## **ADDENDUM NUMBER 2**

**BRADLEY ES & MARSHALL ES**  
**CANOPY REPLACEMENT**  
**Bid No. F13-07**

***SAN BERNARDINO CITY UNIFIED SCHOOL DISTRICT***

April 11, 2014

**Item Number 5;** Reference Marshall Sheet A-4 – Marshall Covered Walk @ Bldg 'A' Demo & New Work; Replace this sheet with attached sheet **A-4 – Marshall Covered Walk @ Bldg 'A' Demo & New Work**

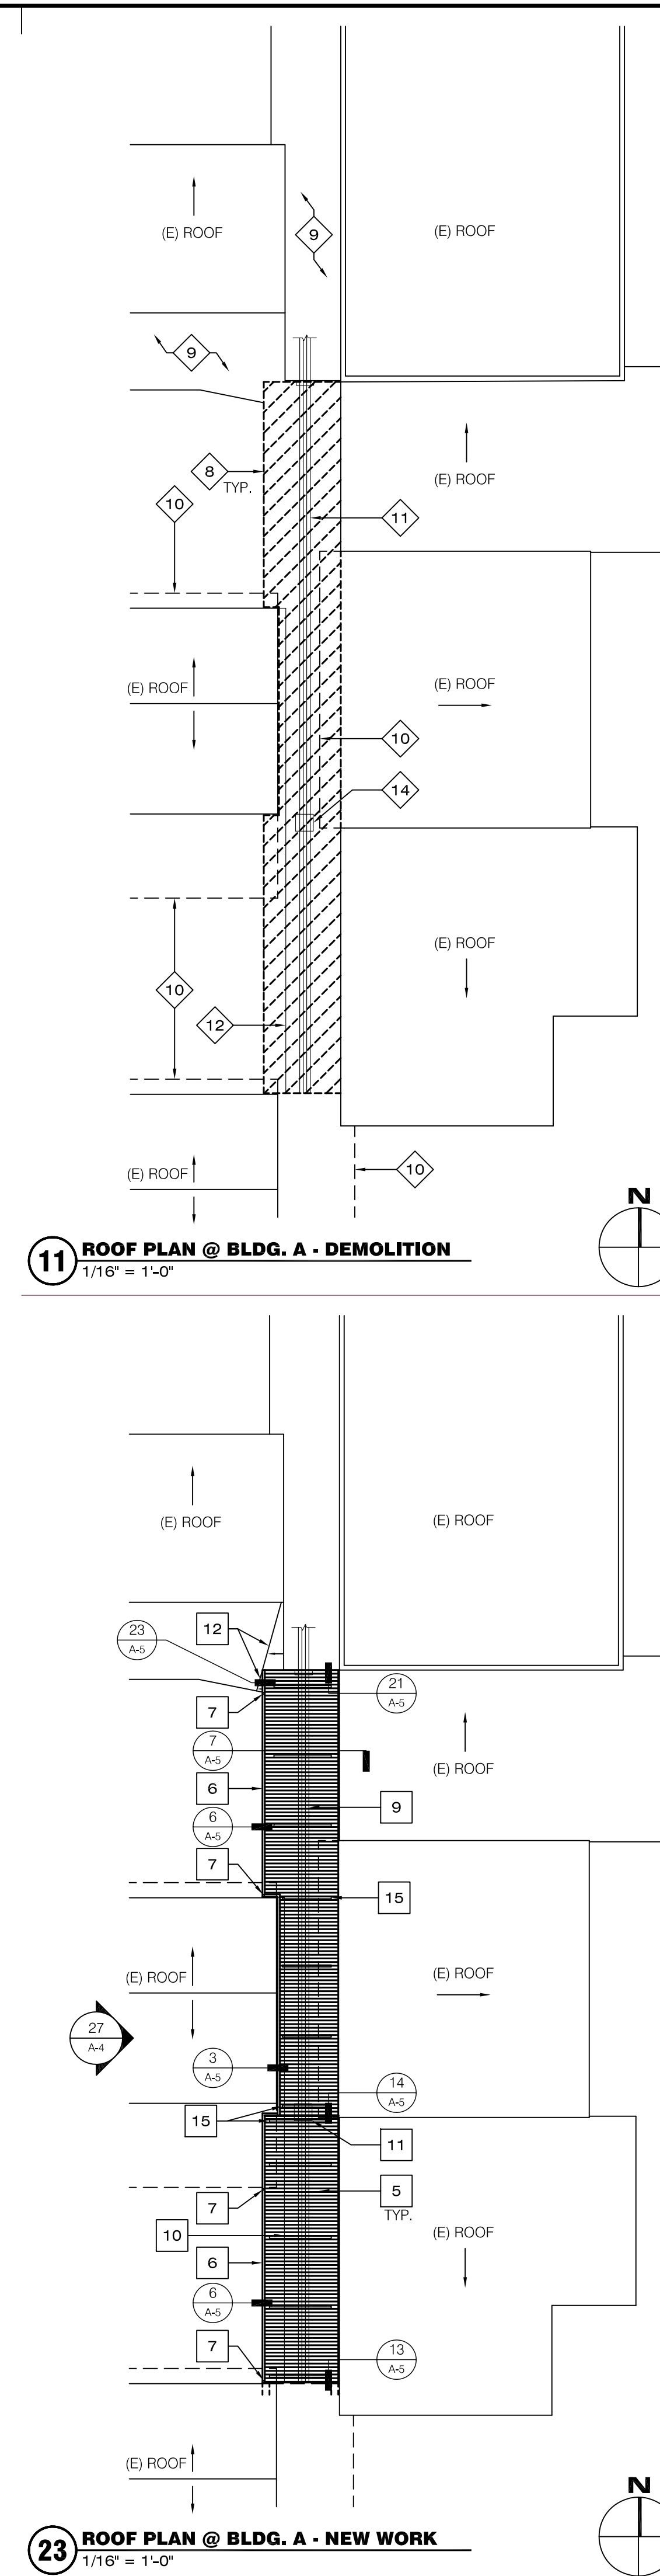
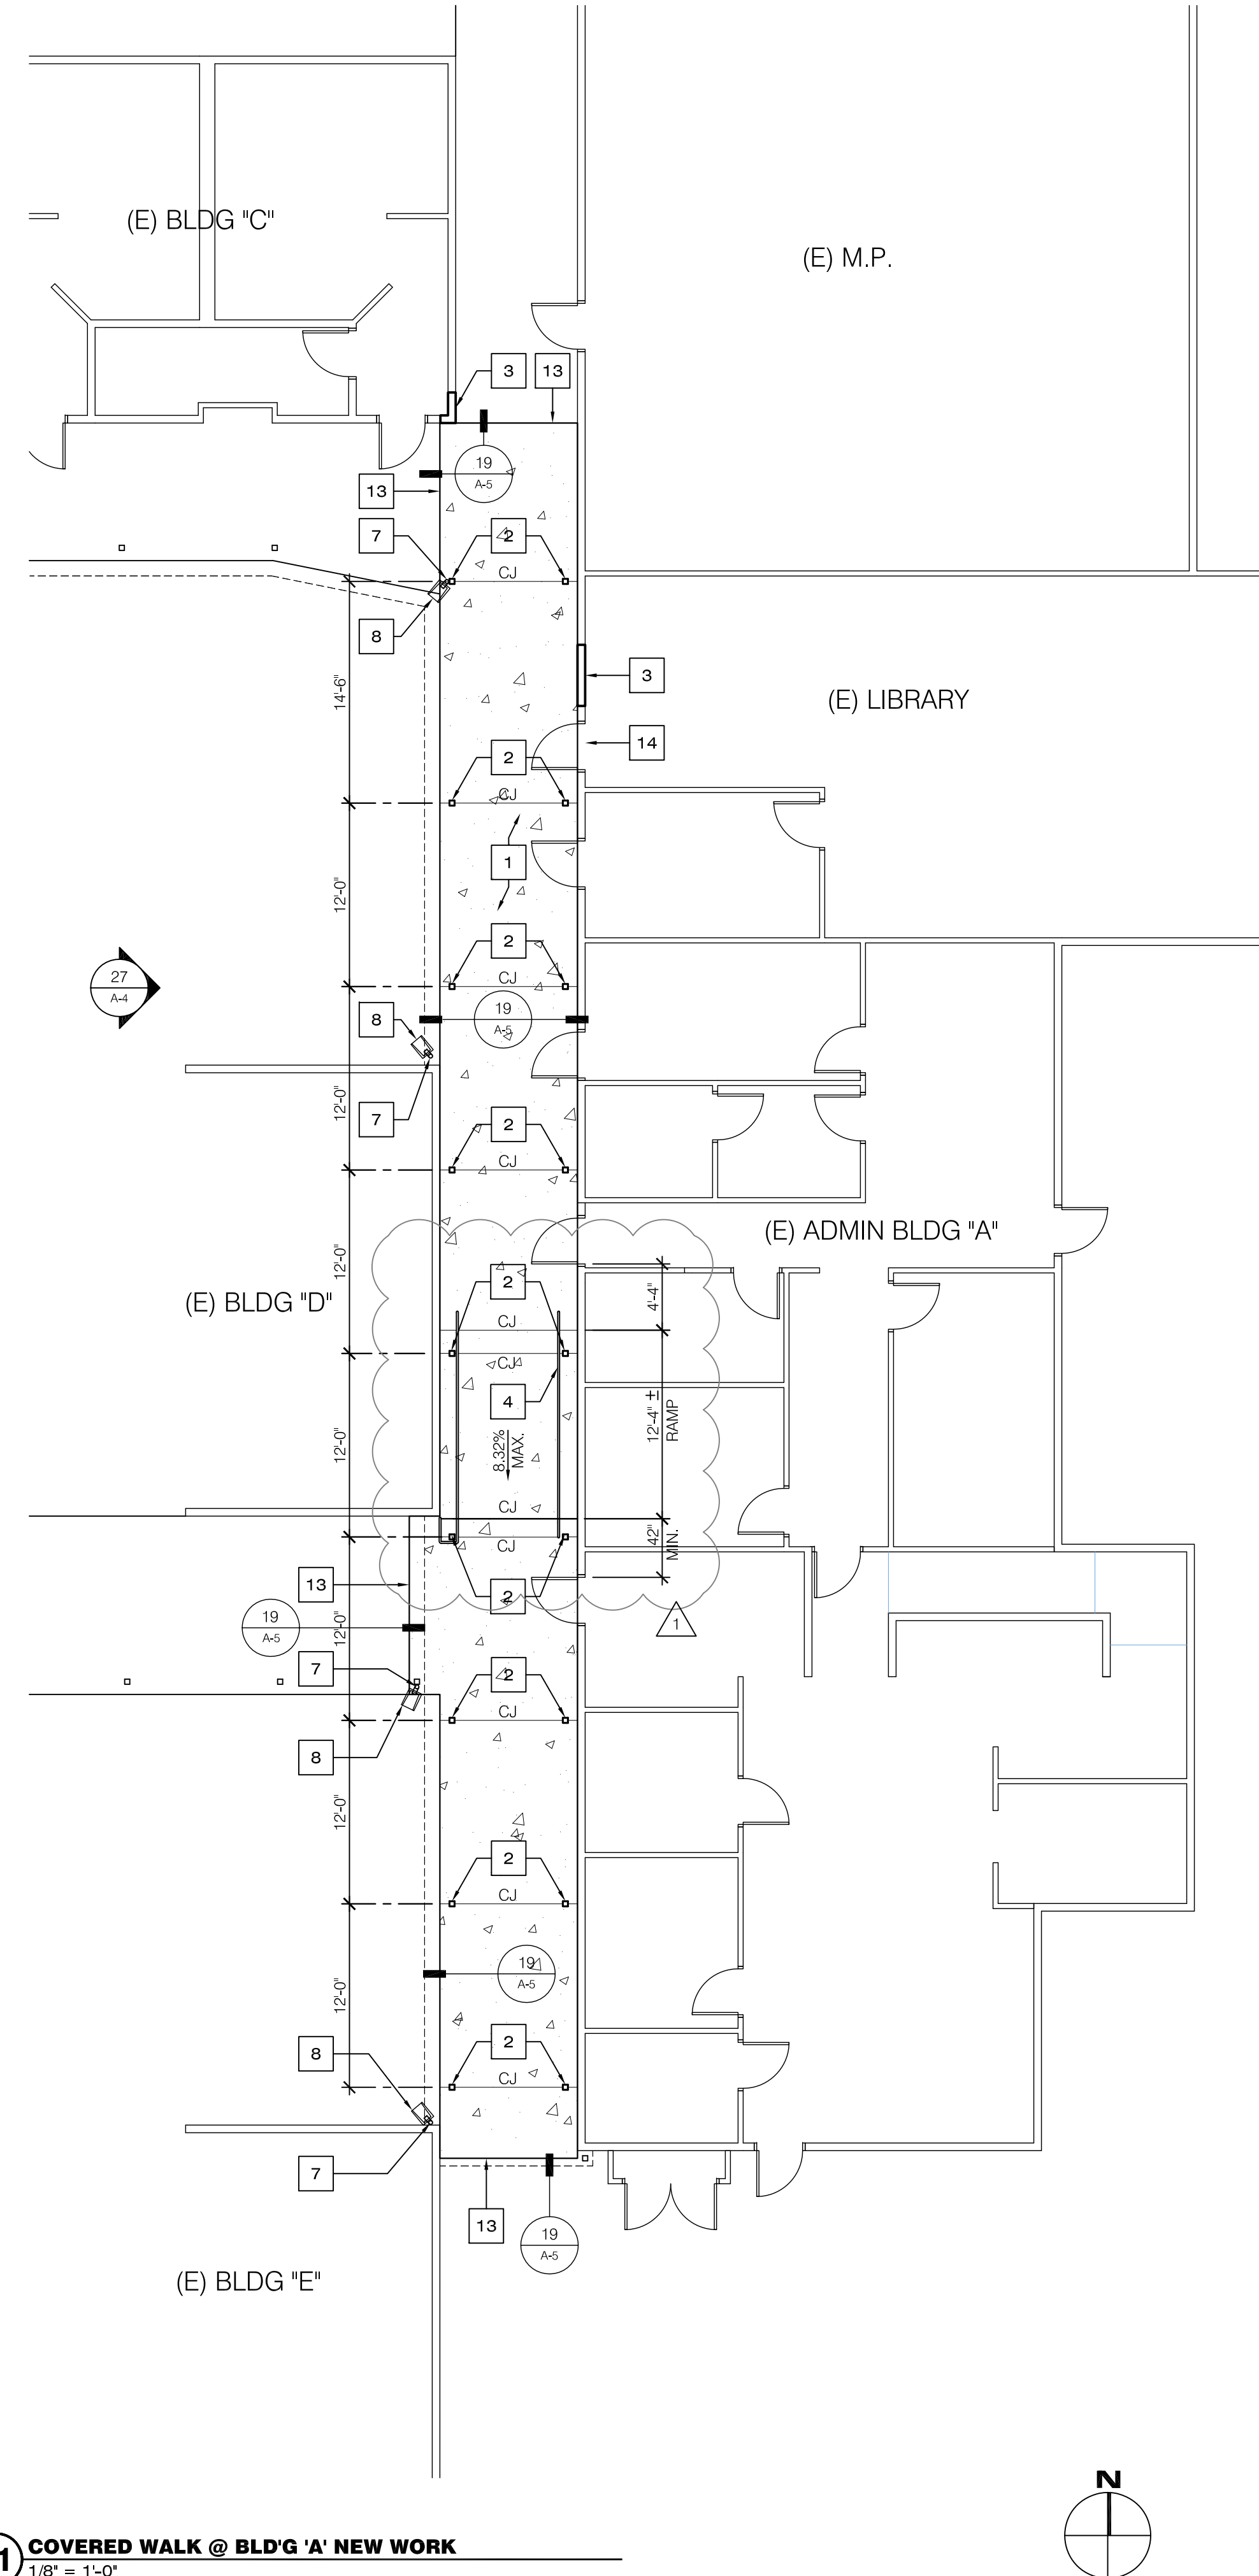
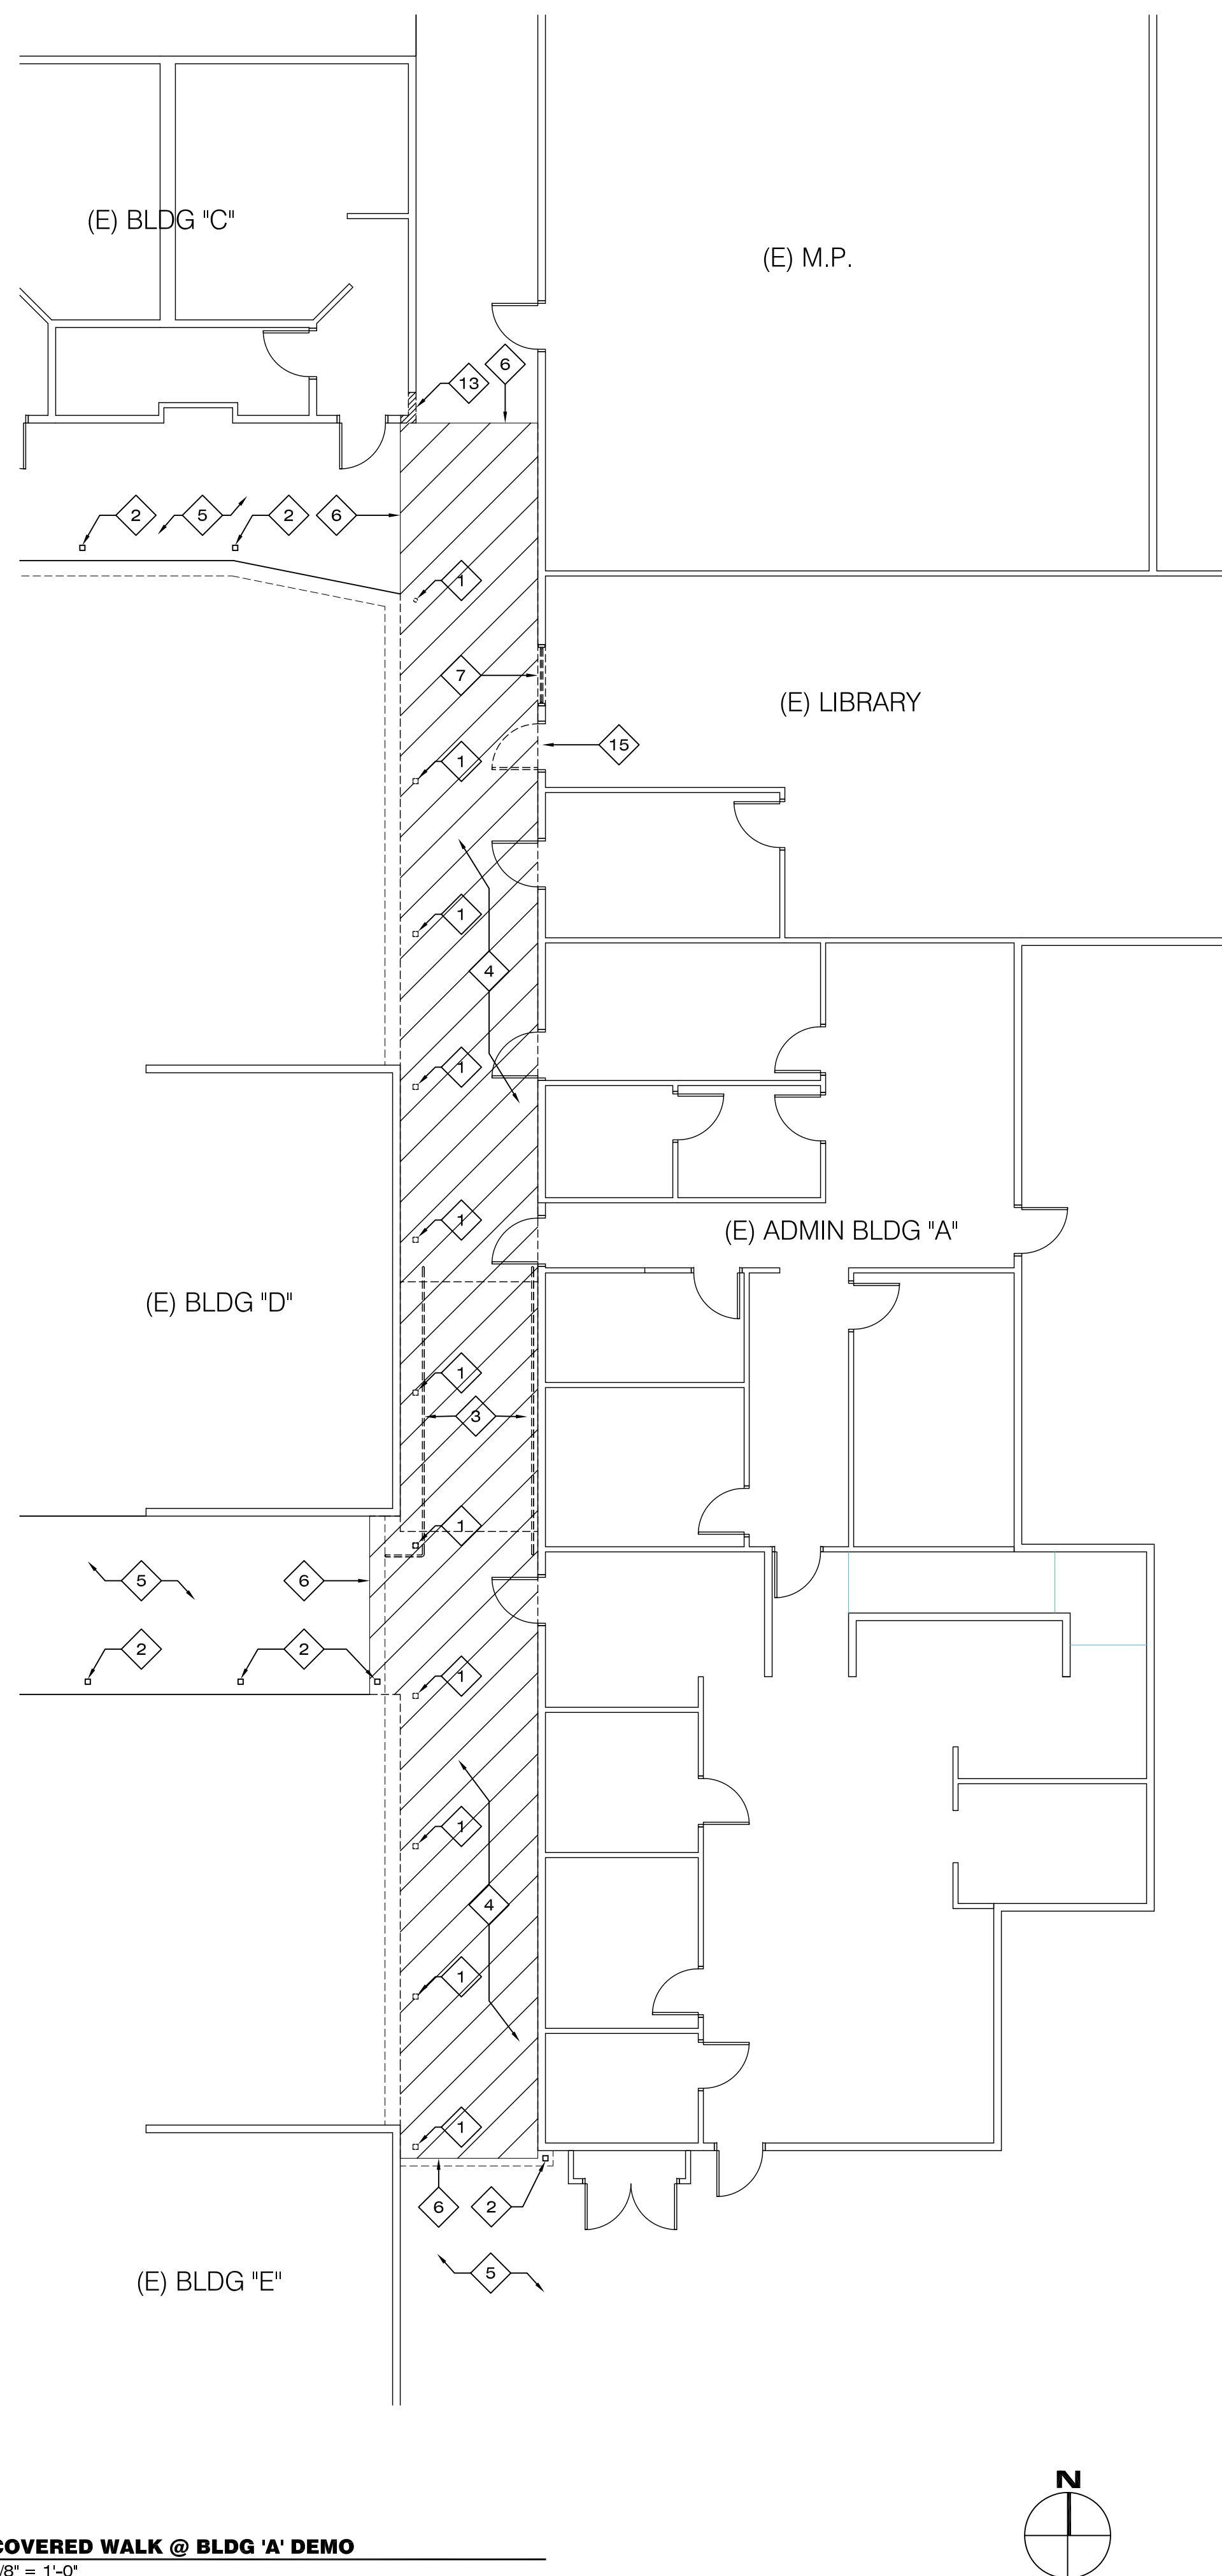
Note: Changes are identified by Delta 1 symbol
